# Access Compliance Report

## Public Rights-of-Way

| Intersection ID: 29262                  | Main Street: SPARROW_VALLEY_WY | Cross Street: POINTER_RIDGE_DR          | Location: E            |
| ADA ID: D87FD945A0BE                    | Ramp Type: PerpDiag            | Initial Pass/Fail: Fail                 | Overall Compliance: No |

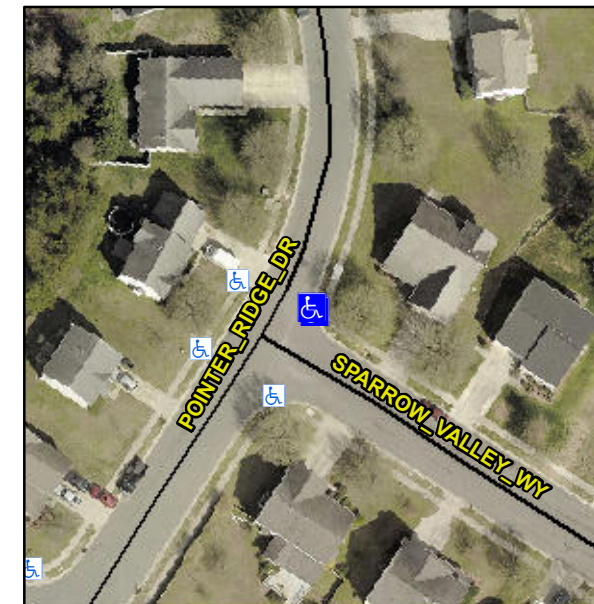
**Not Found, R304.5.1, R304.2.2, R304.5.3**

| Compliance | Description           | Data  | Compliance | Description                 | Data  |
|------------|-----------------------|-------|------------|-----------------------------|-------|
| N/A        | Ramp Length (in)      | 51.0  | No         | Ramp Slope (%)              | 13.5  |
| No         | Ramp Width (in)       | 41.0  | No         | Ramp XSlope (%)             | 5.6   |

**Remove & Replace Curb Ramp With Two New Directional Ramps or Equivalent.**
